Drinking Water Audit Report

| Plant(s) visited: | Breanlee (1300PUB1094) | Date of issue of Audit Report: | 12/08/2014 |
| | | File Reference: | DW2010/8 |

Photograph 1: Catchment

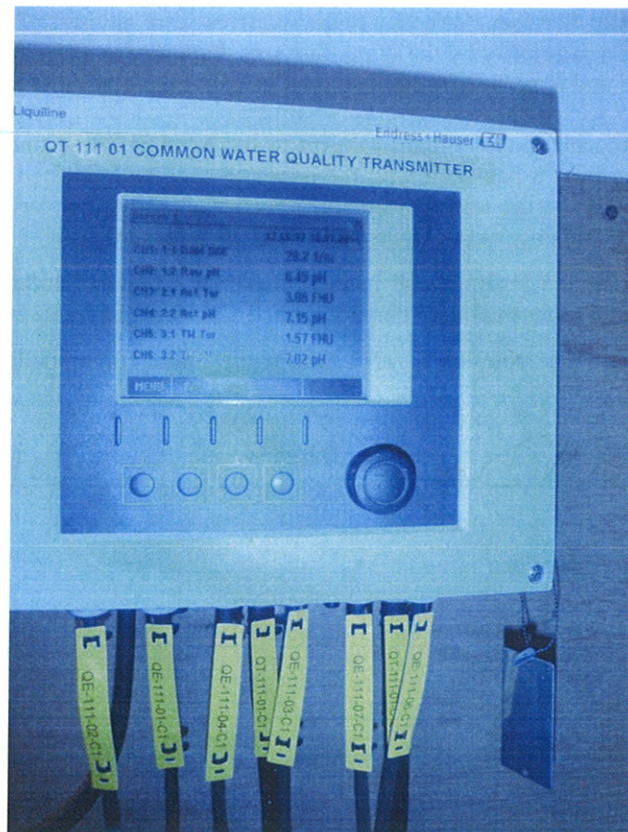
| 1. | Source Protection <ul style="list-style-type: none">a. The raw water source is a tributary of the Cottoners River, an upland mountain stream (see photograph 1).b. Sheep mainly graze the mountainous commonage catchment (see photograph 1).c. The abstraction point was surrounded with both an inner and an outer protection fence.d. There is a turbidity meter on the raw water, the reading on the day was 1.29 NTU. This monitor is not alarmed and there was no calibration sticker observed on the monitor.e. The <i>Cryptosporidium</i> risk score for this supply was calculated in October 2013 as moderate risk.f. KCC stated that the raw water quality is variable, especially after heavy rain fall, and that this can lead to issues regarding chemical dosing. |

1. The Water Services Authority should continue to characterise the variability in raw water quality. Trends in raw water quality should be analysed and used to determine the optimum treatment conditions, and compared against the calibration dosing curve.
